Interstate 580/Patterson Pass Road/International Parkway Diverging Diamond Interchange Improvements Project, CIP 73147, Federal Project Number: ACSB1IM-580-1(982)E

Subject: Addendum No. 4

ADDENDUM NO. 4

4 ADDED PER ADDENDUM No. 4 DATED MARCH 25, 2024 DRAINAGE DETAILS MINOR CONCRETE (Misc CONSTRUCTION) OVERSIDE DRAIN NO SCALE

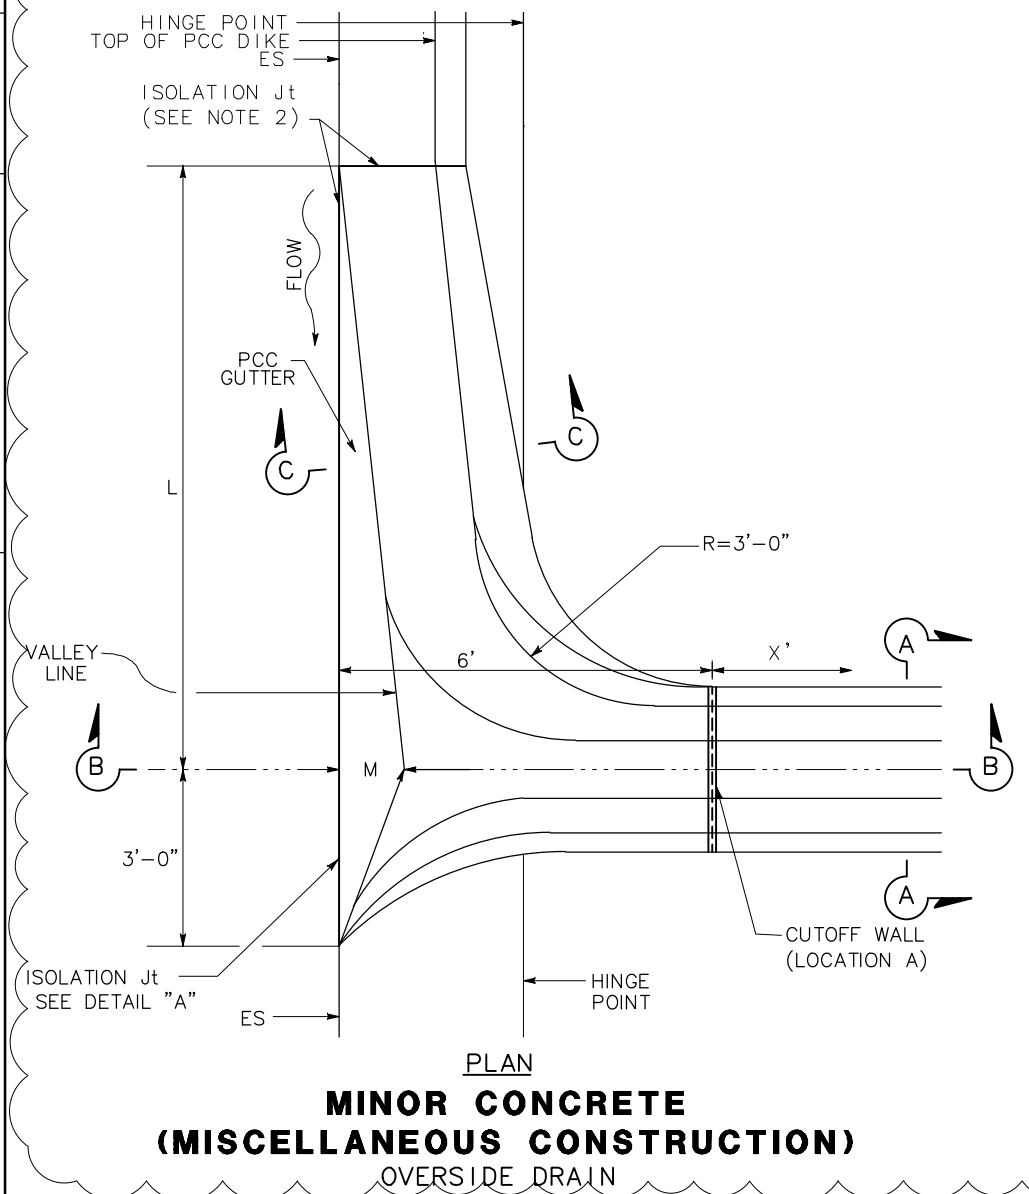
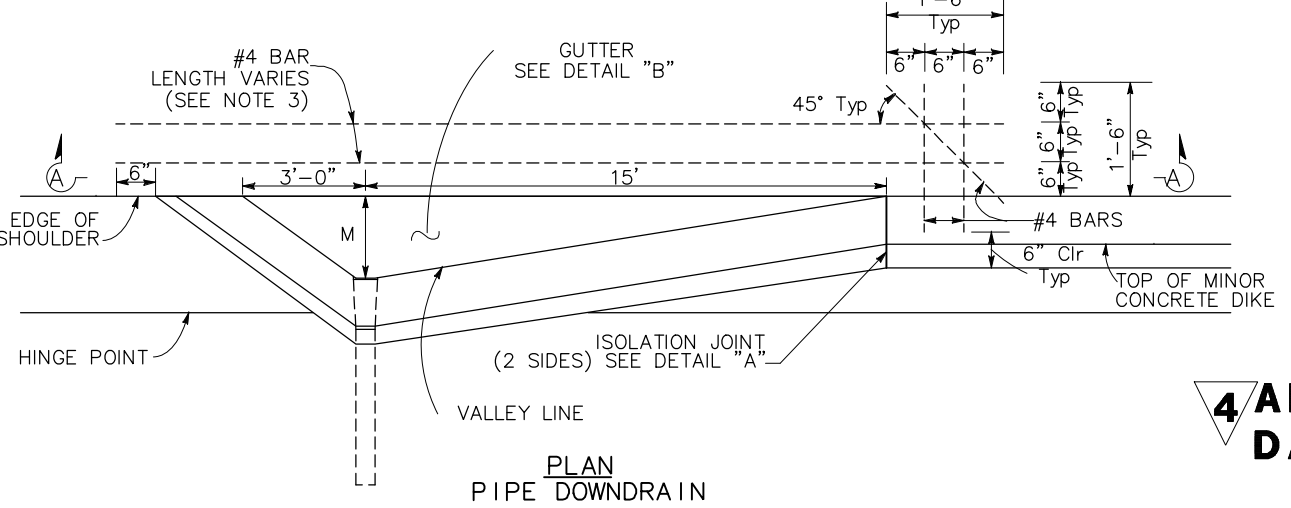
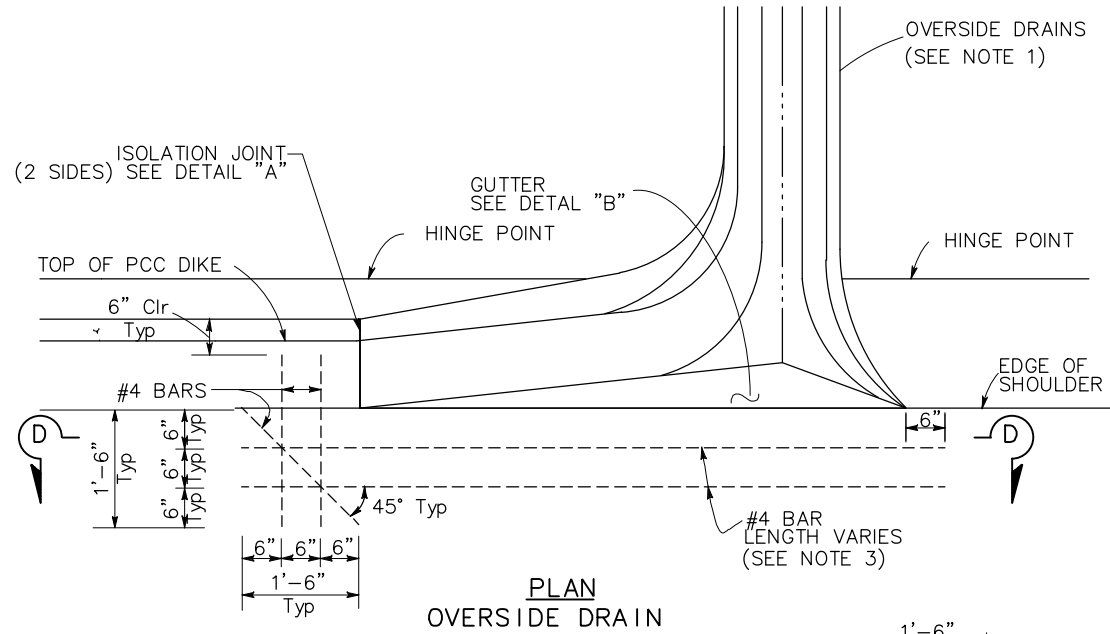
Q4.40 Caltrans Standard Plan D87D for Overside Drains indicates details for Hot Mix Asphalt and corrugated metal flume sections. We have been unable to locate a detail indicating concrete overside drains. Plan Sheet DD-3 does depict a concrete overside drain, but does not provide dimensions or whether reinforcing is required.

A4.40 Refer to the revised detail on Sheet DD-4a included in the Addendum Plan set.

TOTAL LENGTH MEASURED ALONG "RW No. 4" LOL = 564.07'
TYPE 5 (CASE 1)

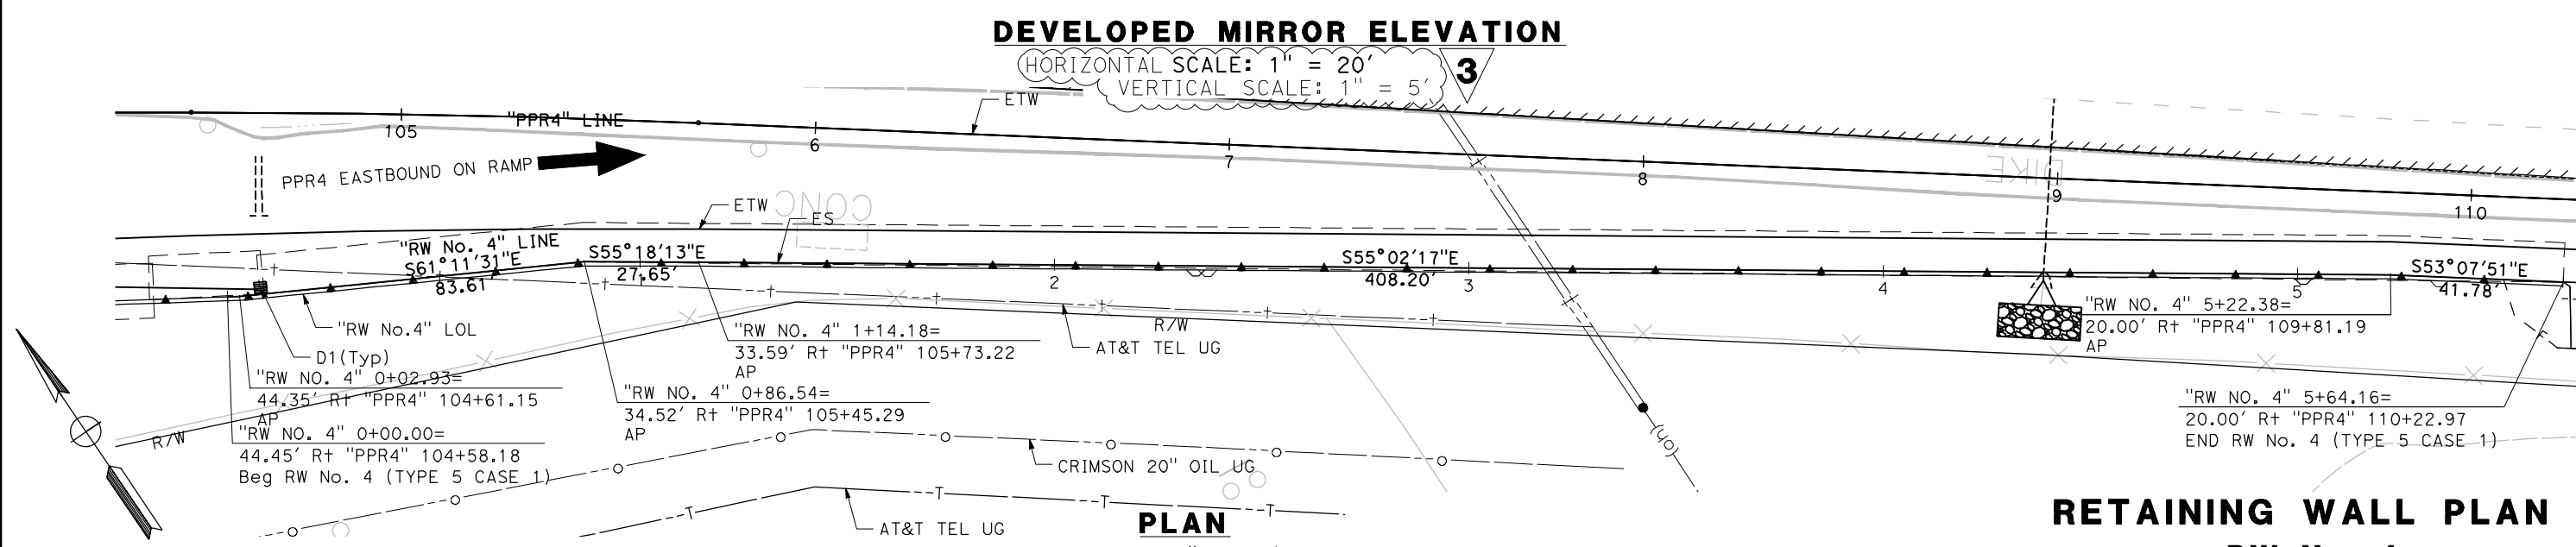
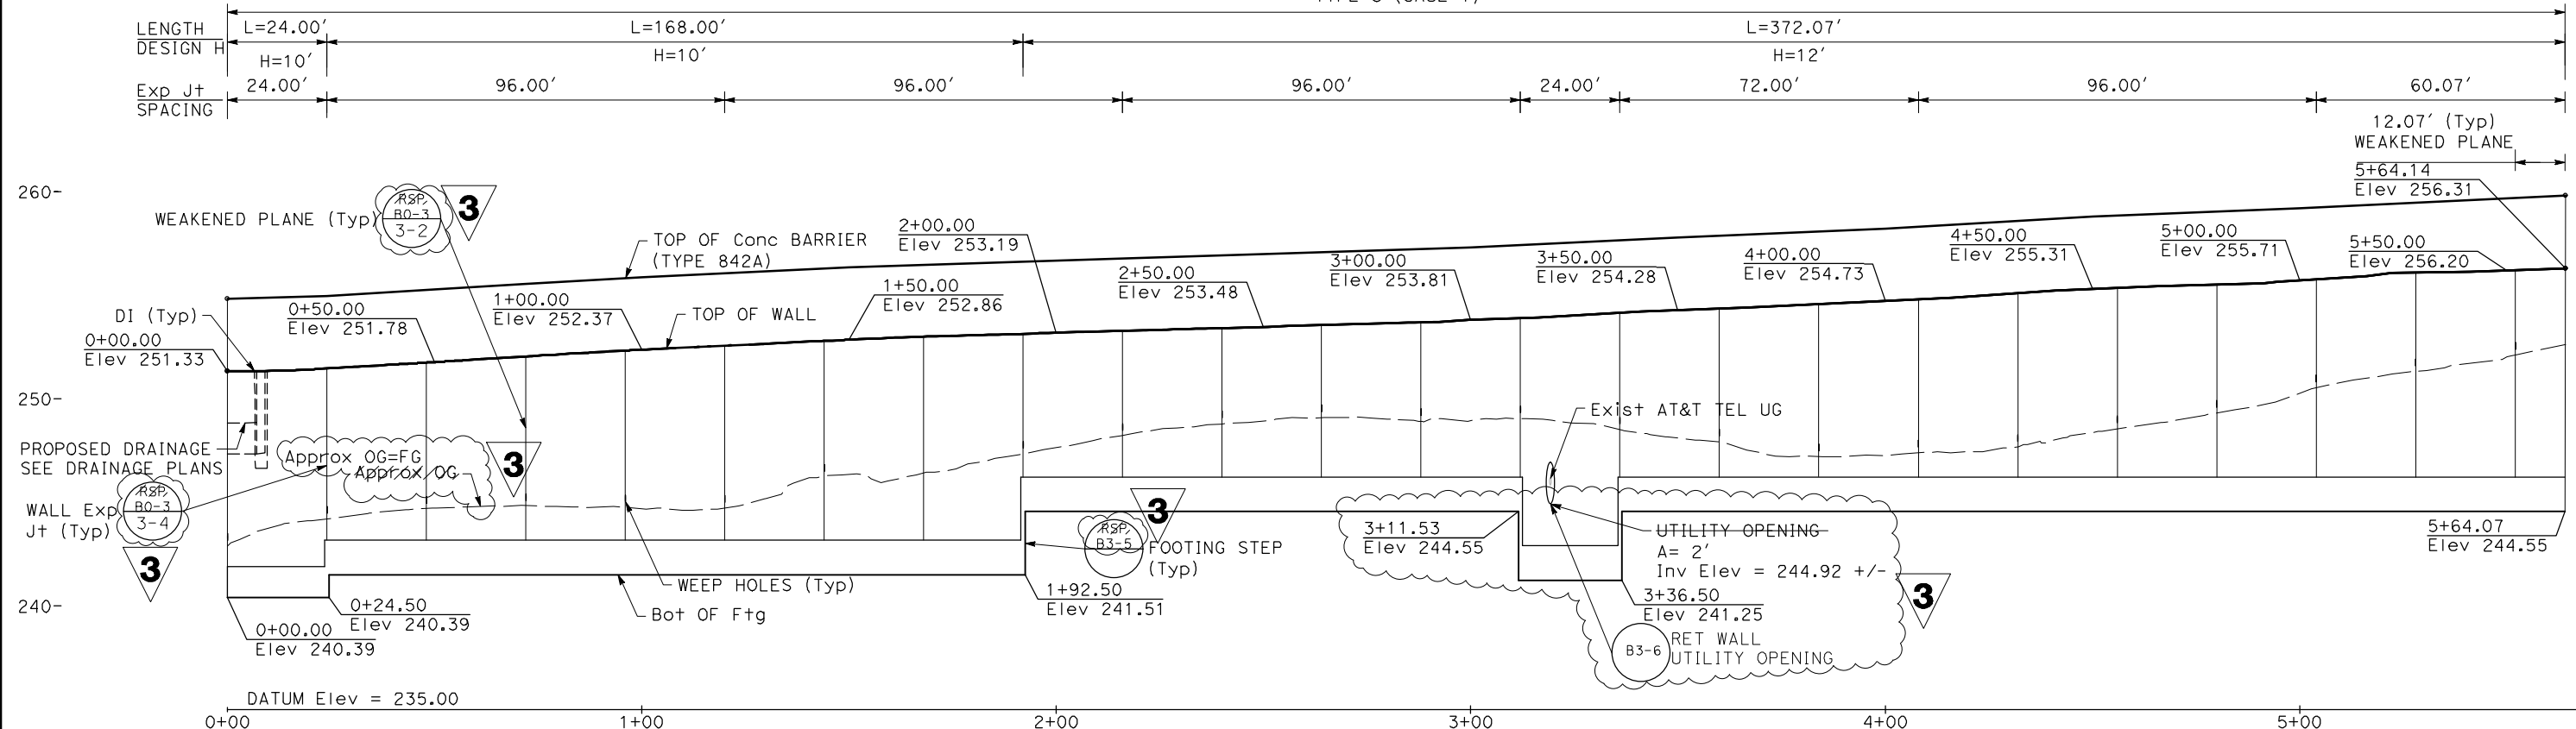
Q4.14 Plan Sheet R-8 (Retaining Wall Quantities) shows Wall #4 as being 153 LF long. Plan Sheet R-6 shows Wall #4 as being 564 LF in length. Can you please verify and adjust quantities for bid item numbers 40, 41, 64, 69 and 123.

Q4.48 Seems to be a discrepancy on the length of R.W No. 4 as well. Please verify if the length should be 153' or 564'? Please adjust the quantity accordingly as well.

A4.14 Retaining wall sheets revised and Bid Schedule revised (See Attachment A).

A4.48 Retaining wall sheets revised and Bid Schedule revised (See Attachment A).
